RE: SES Solar One Project
Applicant's Responses to CEC and BLM Data Requests Set 1, Part 1 and Set 2, Part 1
Data Requests 71-73, 76-79, 85, and 128-141

SES SOLAR ONE

In Response to CEC & BLM Data Requests
Data Requests 71-73, 76-79, 85, and 128-141

Application for Certification (08-AFC-13)

**PROPOSED WATER WELL LOCATIONS
SOLAR ONE AND THREE PROJECTS**

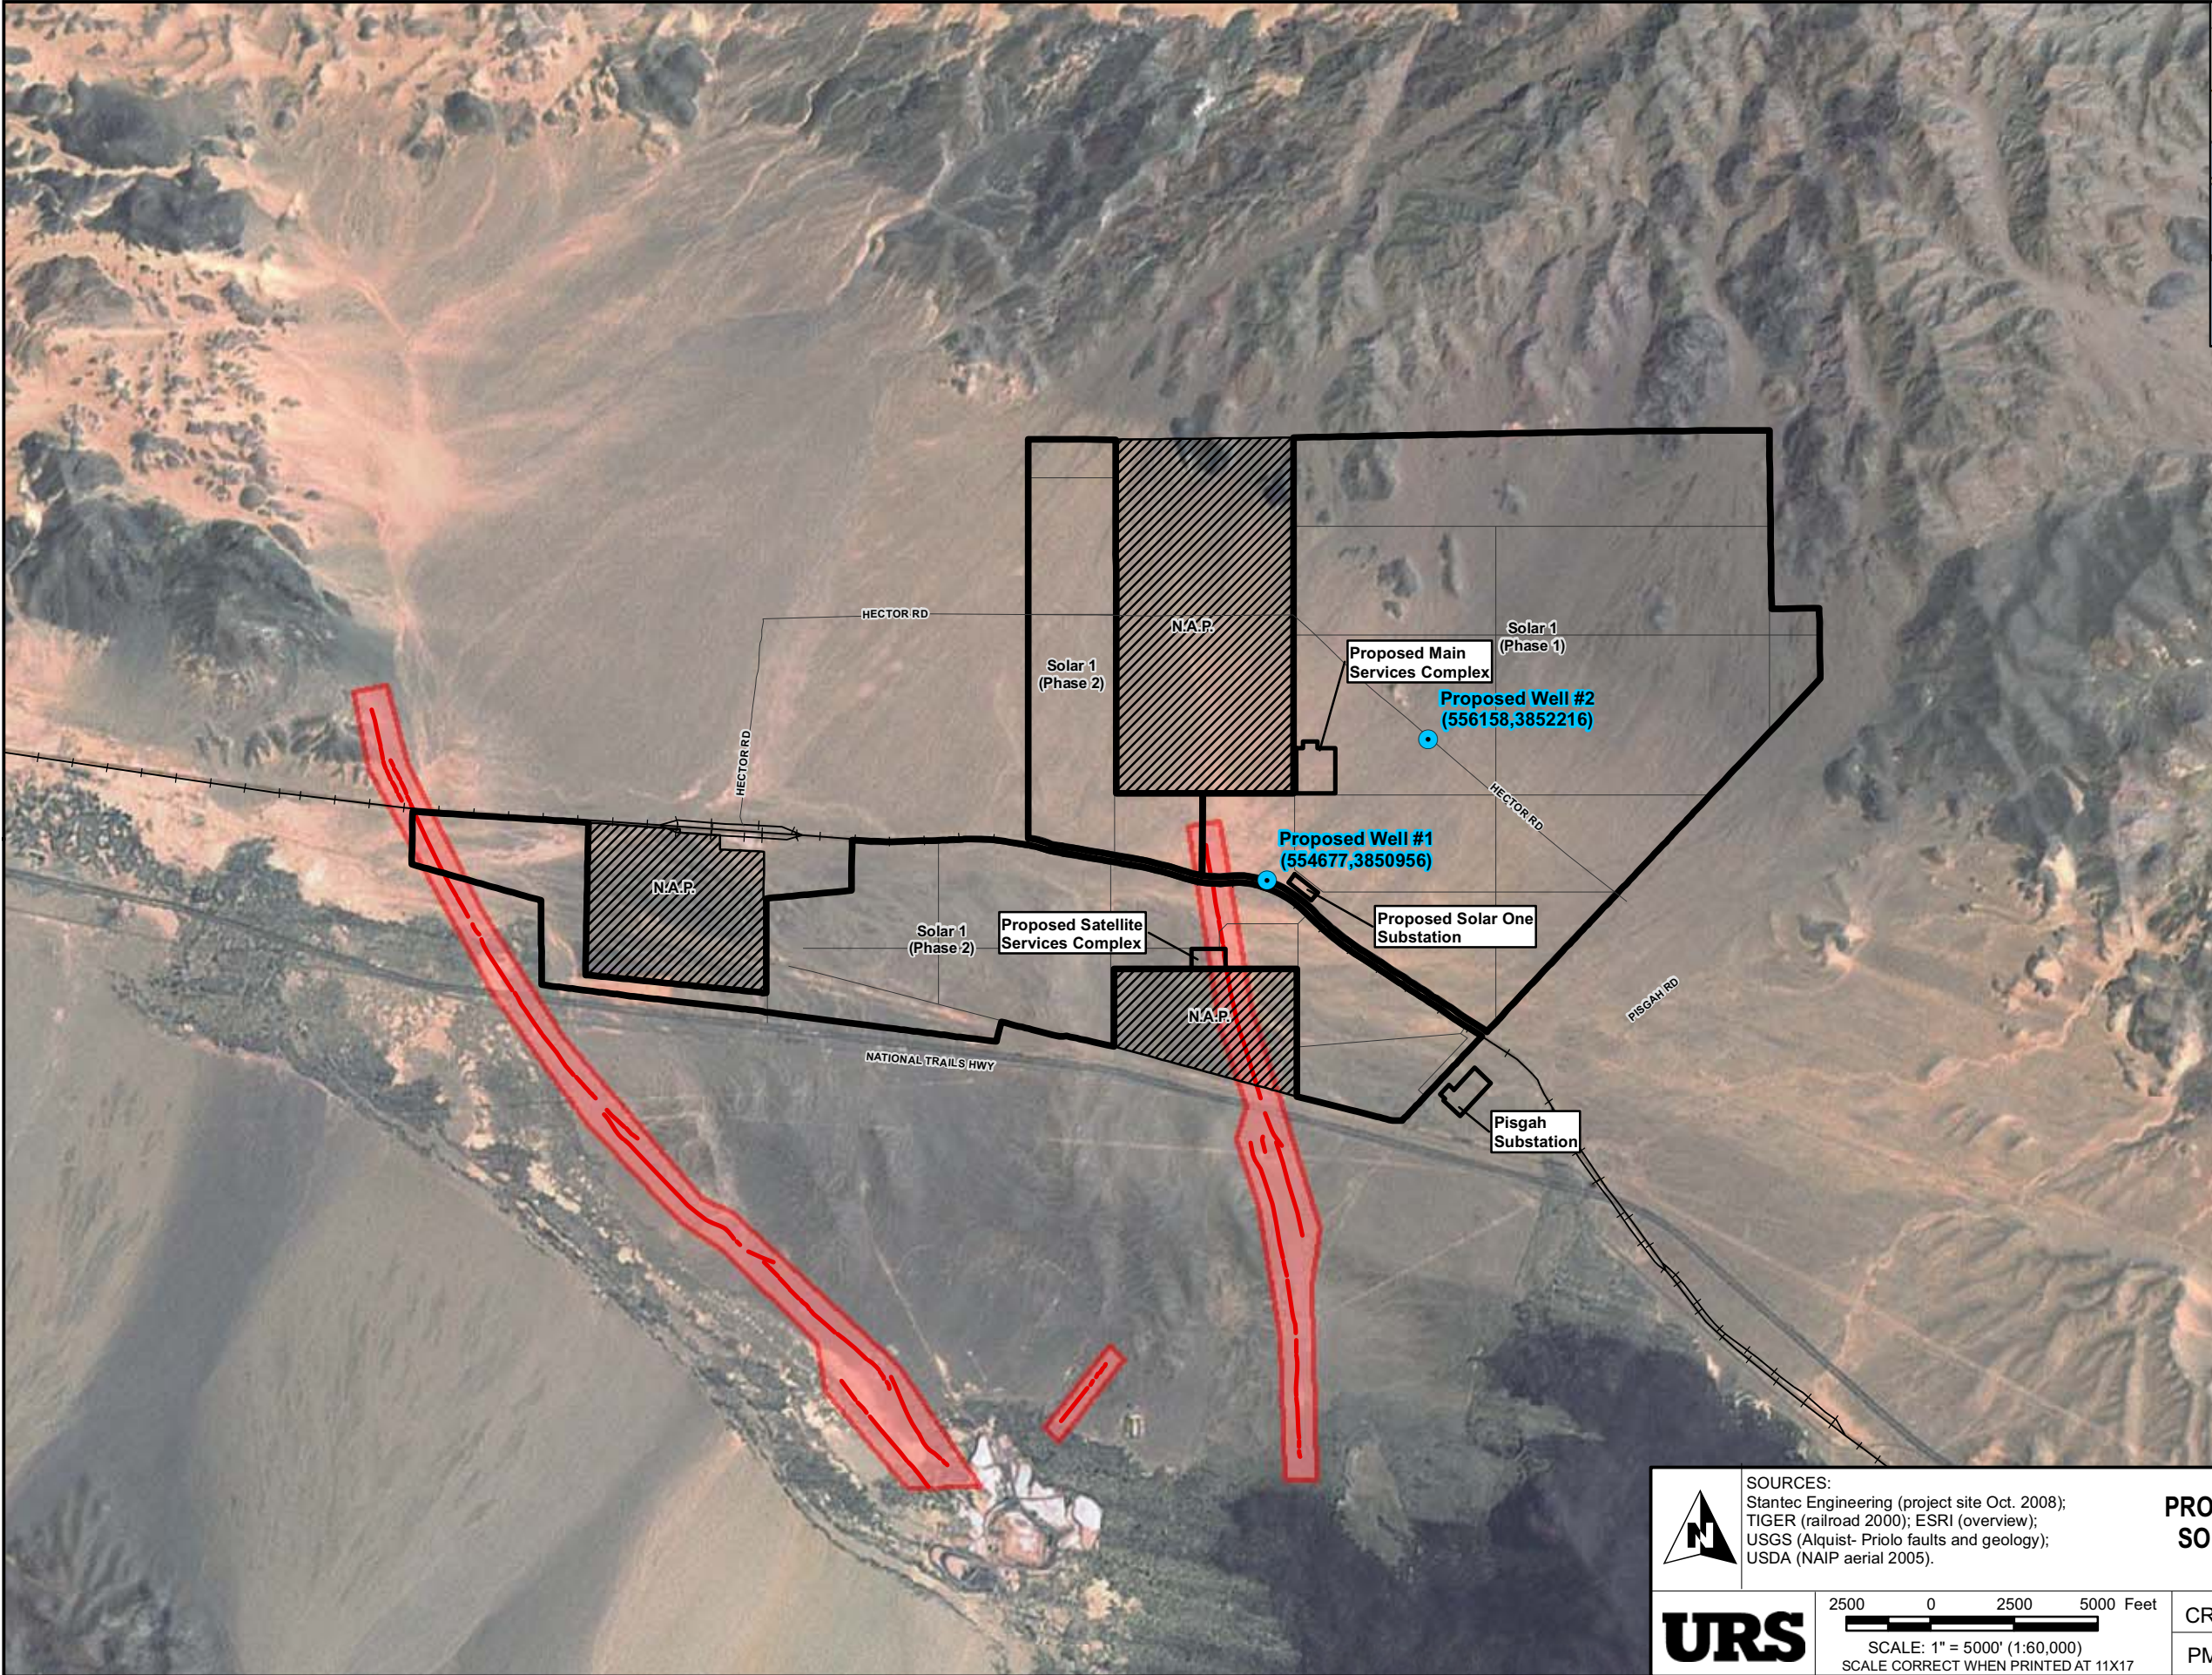
Data Request 77: Please describe the locations and well construction details of the proposed additional wells.

Response: The proposed location of an additional water supply well is shown on attachment SWR-1, located behind this response. The proposed location of Well #1 is in T8N R5E Section 12. The proposed location of Well #2 (currently preferred primary well location) is in T8N, R6E Section 6. Well construction details will be provided after test well construction. The attached well development program specifies the well drilling, installation, development and aquifer testing procedures.

CAMP ROCK ROAD
PROPOSED ALTERNATIVE SITE
SOLAR ONE PROJECT

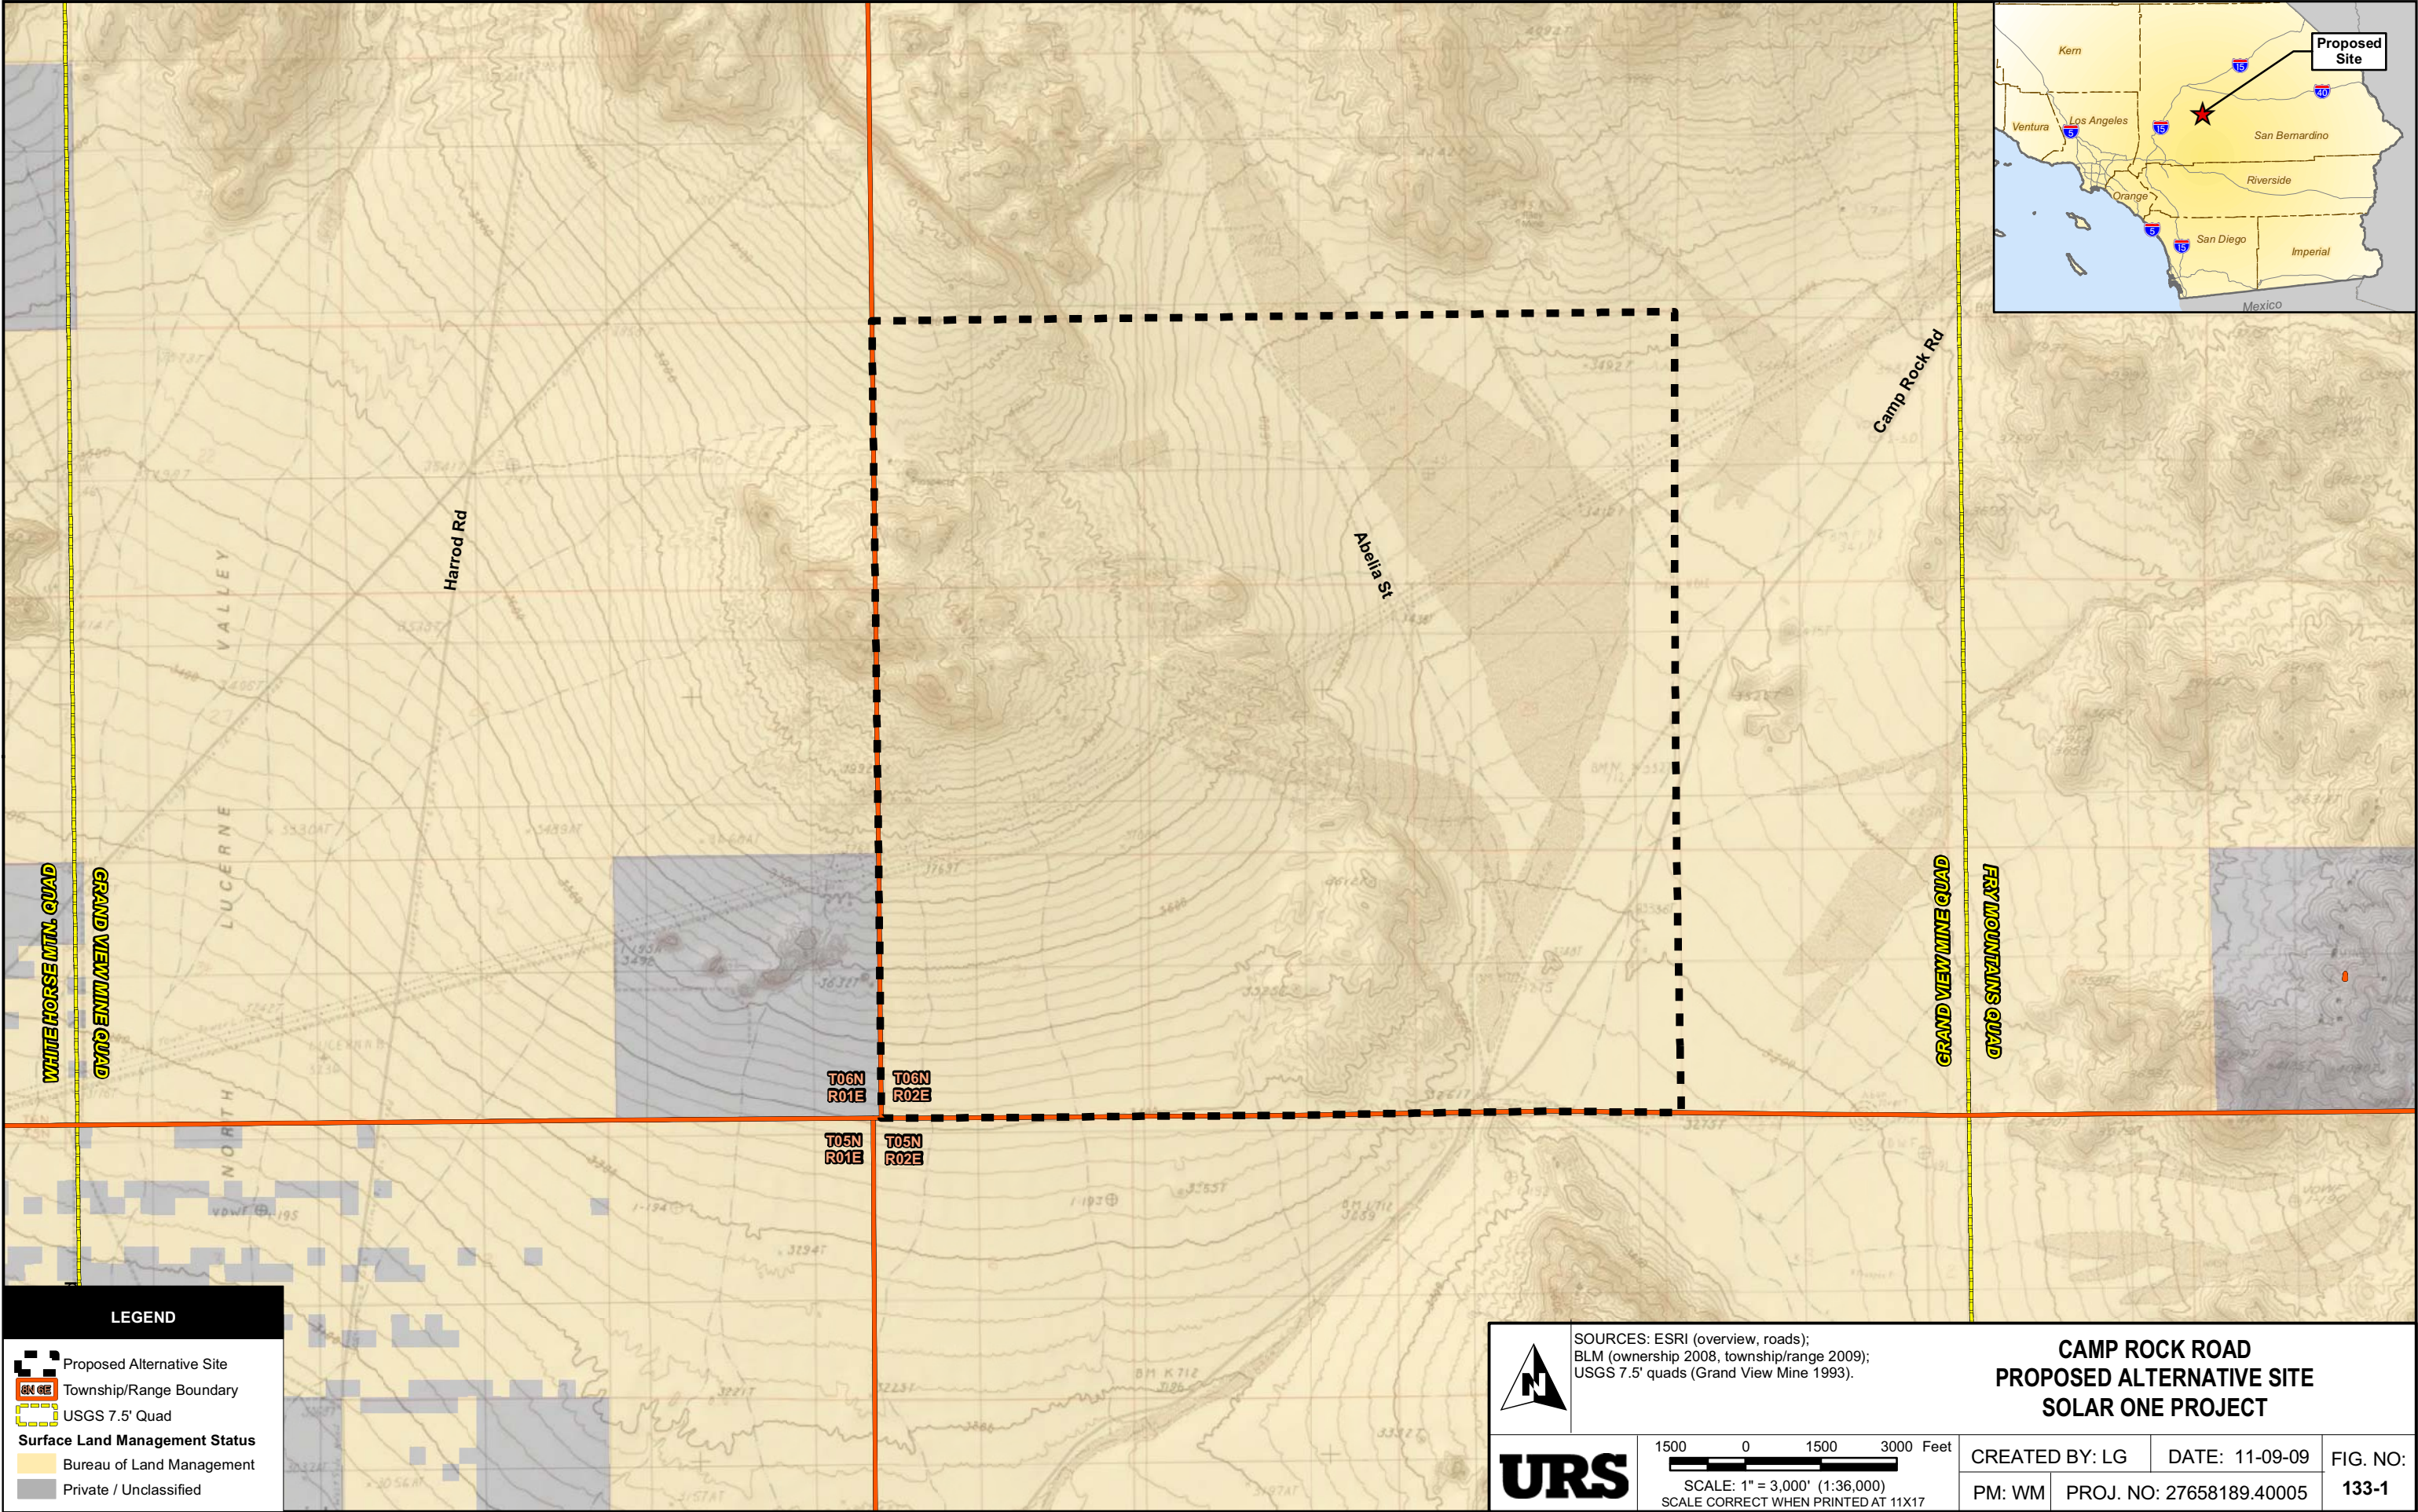
Please prepare separate maps at a scale of 1:36,000 for each of the five alternative sites. For each site, an aerial or topographic map should have overlays of the site boundary, township ranges, and property parcels. Label roads and other features.

Please see figures 133-1 thru 133-5 provided behind this response as attachment ALT-1.
